Remarks:

In the February 12, 2004, Office Action, the drawings were objected to under 37 C.F.R. 1.83(a). On the merits, Claims 75-78, 81-85, 89, 90, 92, 96-98, 101-105, 109, 110, 112, and 117 were rejected under 35 U.S.C. Section 102(a) as being anticipated by Plourde. Claims 75-78, 81-85, 89, 90, 92, 96-98, 101-105, 109, and 112 were rejected under 35 U.S.C. Section 102(e) as being anticipated by Plourde. Claims 86-88 and 106-108 were rejected under 35 U.S.C. Section 103(a) as being unpatentable over Plourde. Claims 91 and 111 were rejected under 35 U.S.C. Section 103(a) as being unpatentable over Plourde. Claims 93-95 and 113-115 were rejected under 35 U.S.C. Section 103(a) as being unpatentable over Plourde. Claim 116 was rejected under 35 U.S.C. Section 103(a) as being unpatentable over Plourde.

ANNOTATED SHEET SHOWING CHANGES

Fig. 3

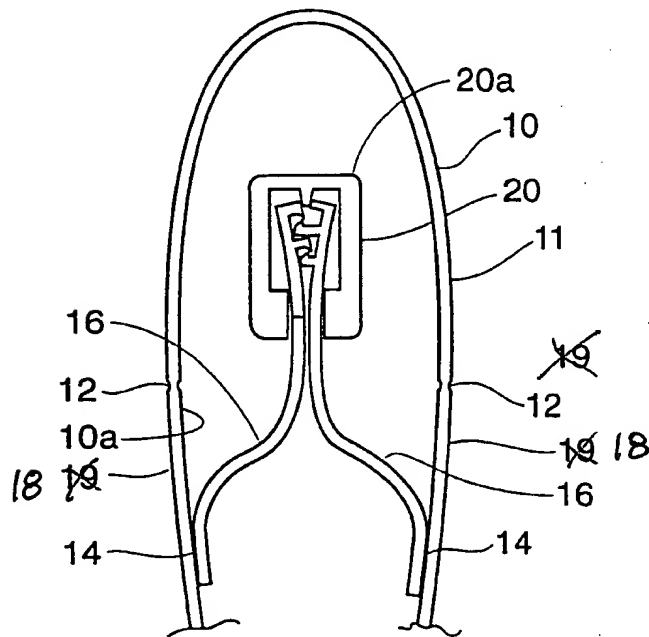
Fig. 3 is being amended to eliminate the use of the reference numeral "19" to refer to a component. Both a marked-up copy of the amended figure and a replacement drawing sheet are being submitted. In the specification, paragraph 81 is also being amended to make the corresponding changes in the specification. This change is being made due to a related application which includes the same figures plus a number of additional figures using the reference numeral "19" in two figures, the second of which is not included in the present application.
